Subject: UniStar Nuclear Energy, NRC Docket No. 52-016
Response to Request for Additional Information for the
Calvert Cliffs Nuclear Power Plant, Unit 3,
RAI No. 65, Seismic System Analysis, Question 03.07.02-6

**Response to NRC Request for Additional Information,
RAI No. 65, Seismic System Analysis, Question 03.07.02-6,
Calvert Cliffs Nuclear Power Plant, Unit 3**

Question 03.07.02-6

Figure 1: Beta (β) Factors for Foundation Impedance Calculations (ASCE 4-98)

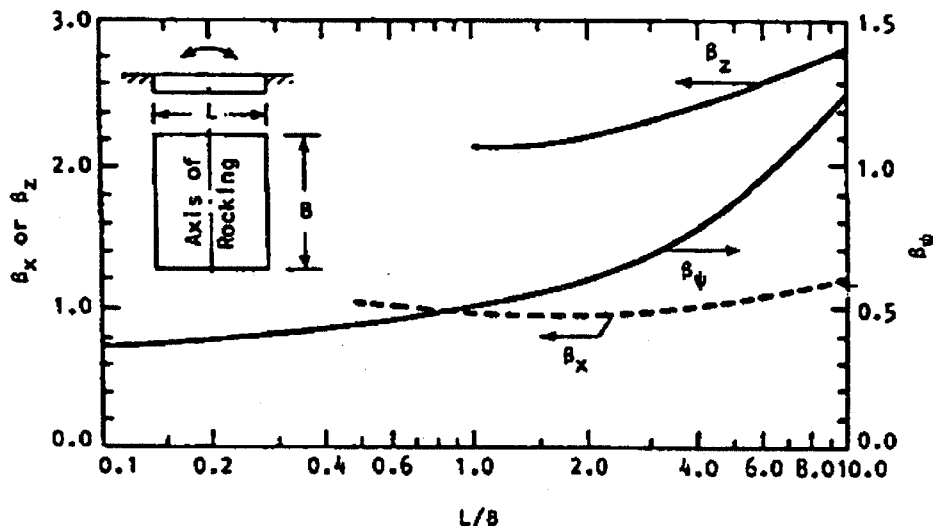
- The method and formulas used to calculate the values of the soil springs under the foundation as well as the lateral soil springs that represent the embedment effect.

Provide the method and formulas used to calculate the values of the soil springs under the foundation as well as the lateral soil springs that represent the embedment effect.

The soil impedances are calculated per Section 3.3.4.2.2 of ASCE 4-98 (Reference 3 of FSAR Section 3.7.2.16). In this methodology, the foundation impedances are first calculated without considering embedment effects. Table 1 depicts the equations used in this first step, and Figure 1 shows the beta (β) factors required during the calculations. Lateral soil springs are not used at the soil-wall interfaces to represent the embedment effect. The increase in stiffness due to embedment effects is included by multiplying the stiffness coefficients calculated in the first step by the modification factors listed in Table 2. The increase in the damping coefficients due to embedment was conservatively neglected, as stated in FSAR Section 3.7.2.4.
